**UNIVERSITY OF HOUSTON
Campus Facilities Planning Committee
Agenda Item Description Form**

- 1. Date:** February 2, 2018
- 2. Item:** UH Katy Academic Building Update
- 3. Requesting Department:** College of Engineering, College of Nursing
- 4. Contact Names & Phone Numbers:** Dr. Kathryn Tart, x2-8218,
Dr. Hanadi Rifai, x3-4271, Brenda Svetlik,
(361) 510-4823, Ed Mader, x3-6288
- 5. Presenter:** Ed Mader
- 6. Recommendation/Action Requested:** Approval
- 7. Summary:**

New Katy Campus

UH CFPC Meeting

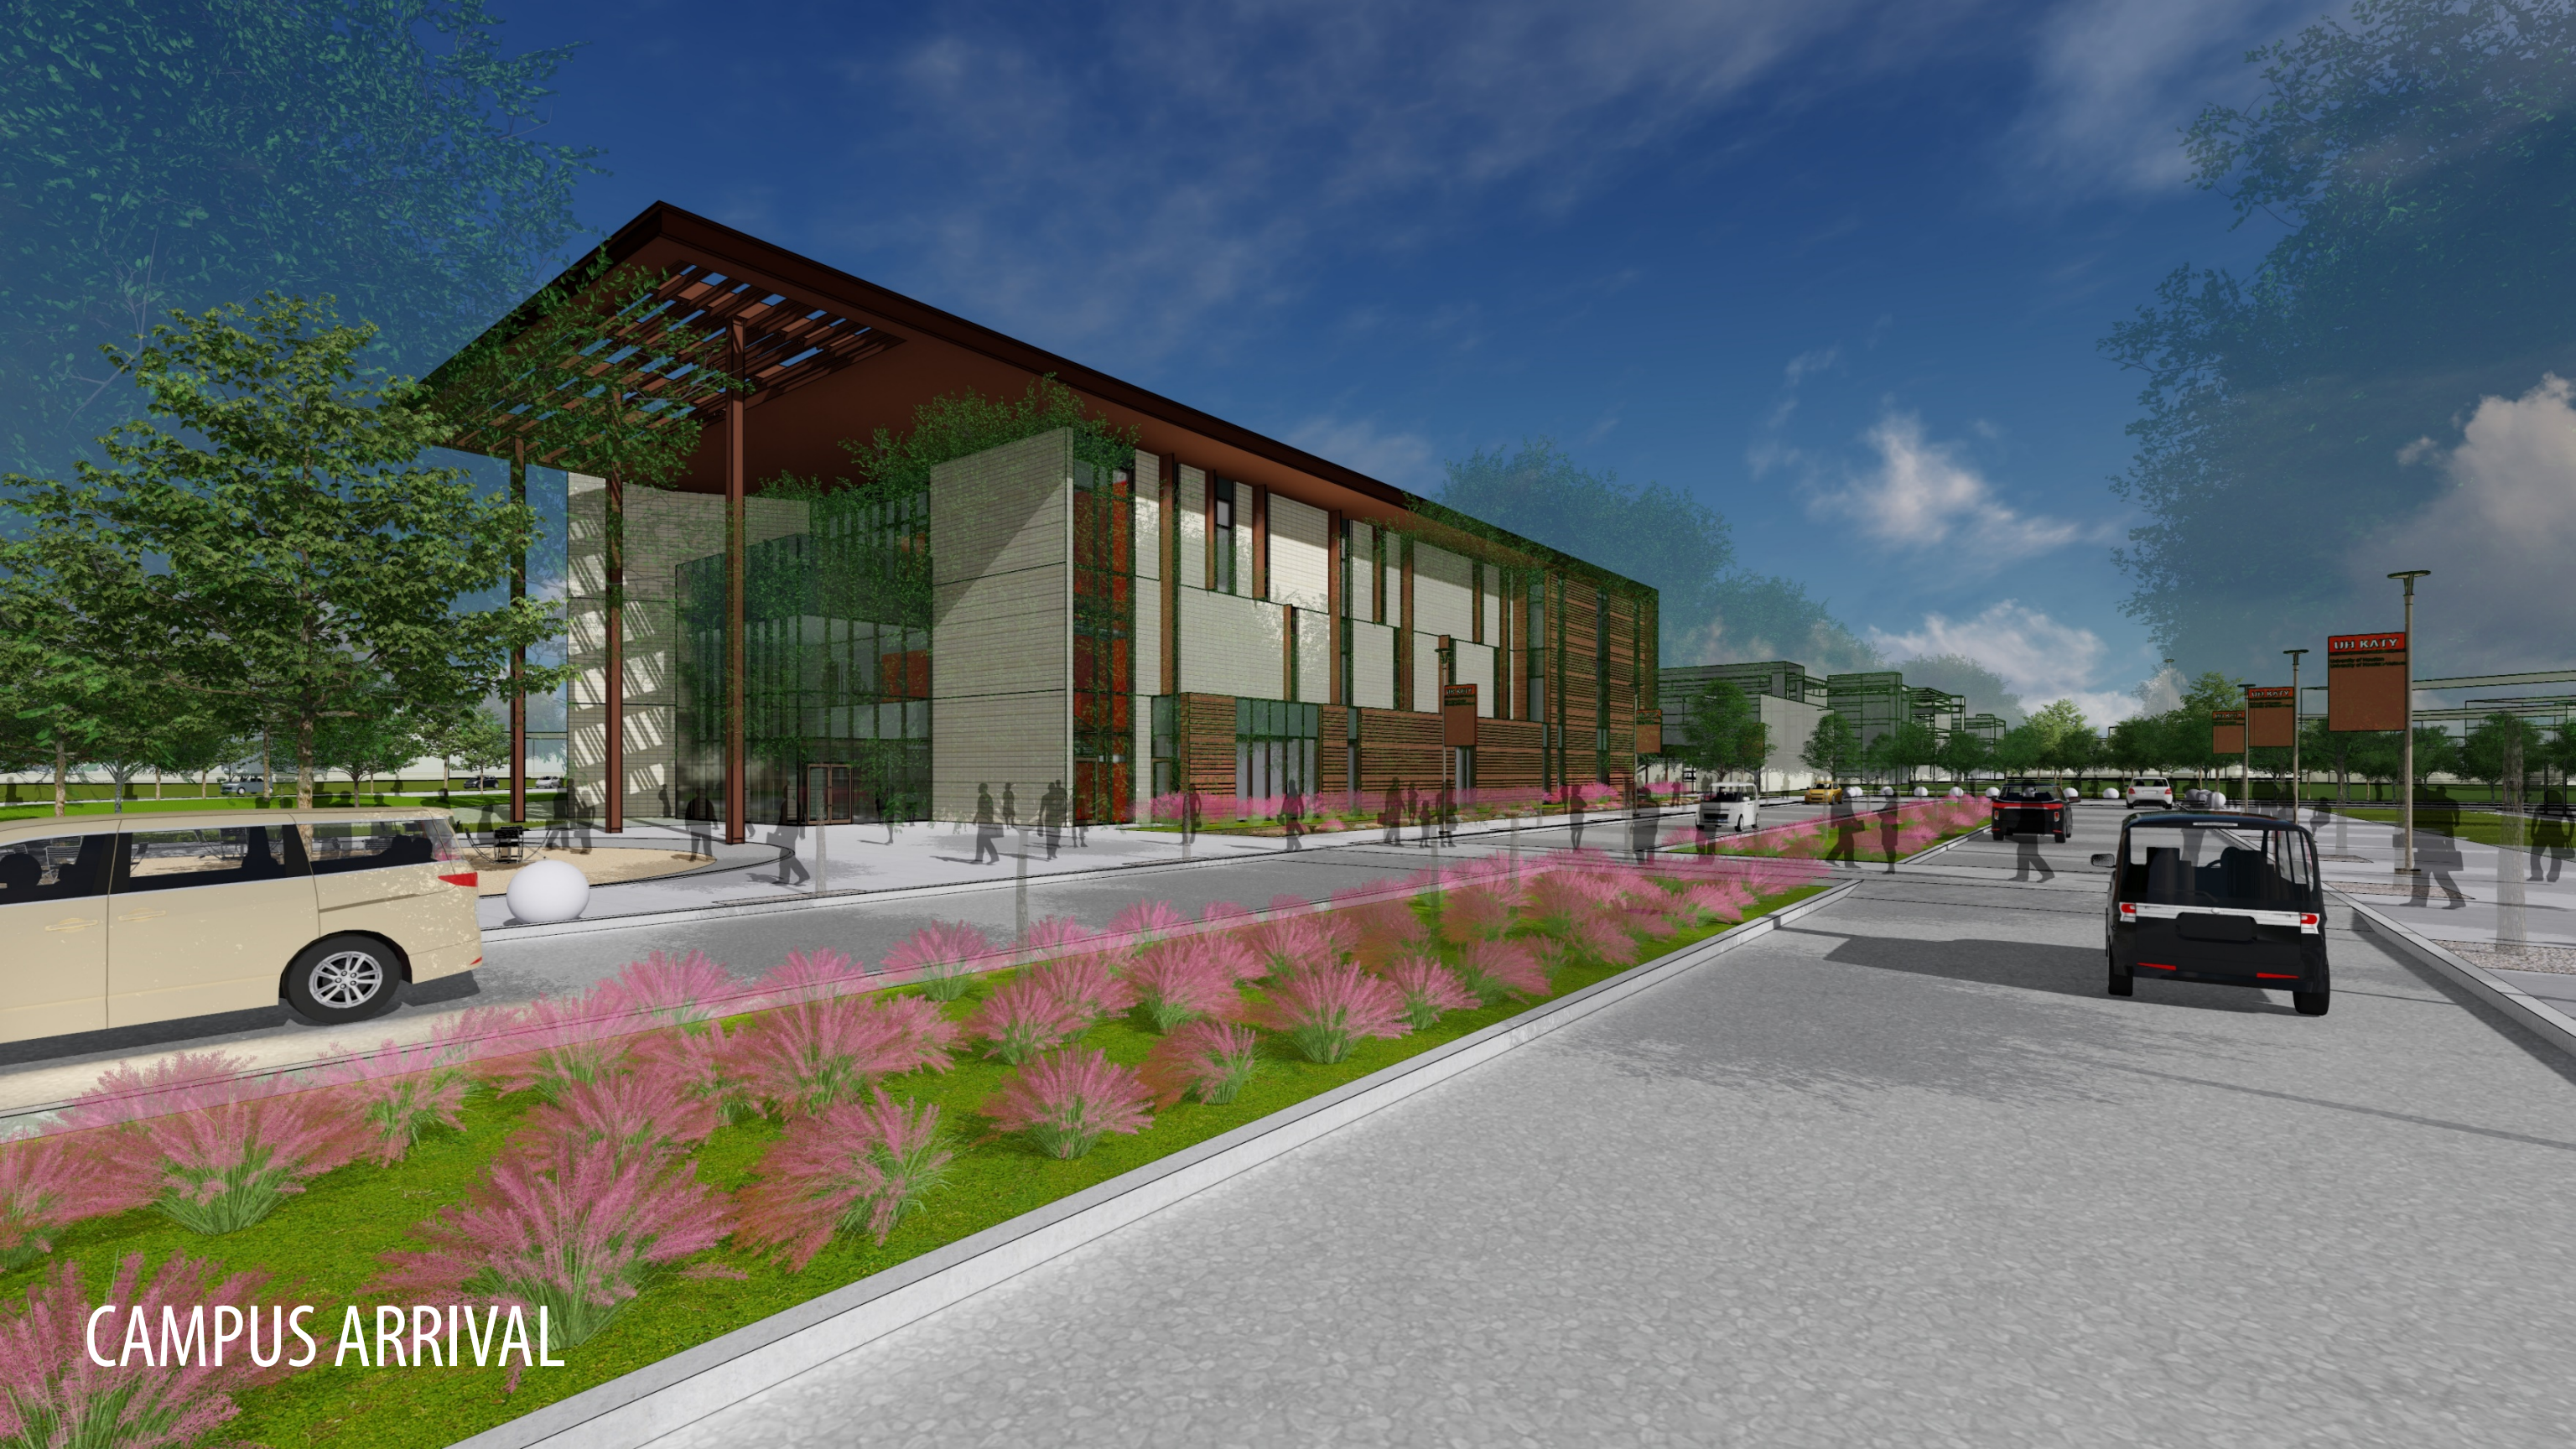
During the electronic voting period the committee requested that the pedestrian crossing between the parking lot and the building entry be relocated to a more convenient and readily used location near the front door. Several members also expressed concern that there was sufficient tree shading on the plaza, and that the deletion of a theater from the current program had adverse effects on the entry lobby.

The design team agrees that the crosswalk should be relocated and that shade trees should be planted to better shade the plaza. The theater was omitted from the design due to space and budgetary considerations. The design team is aware of the importance of the building's arrival sequence and has created a 10,000 SF, two story lobby that can be constructed with the current space and budgetary constraints.
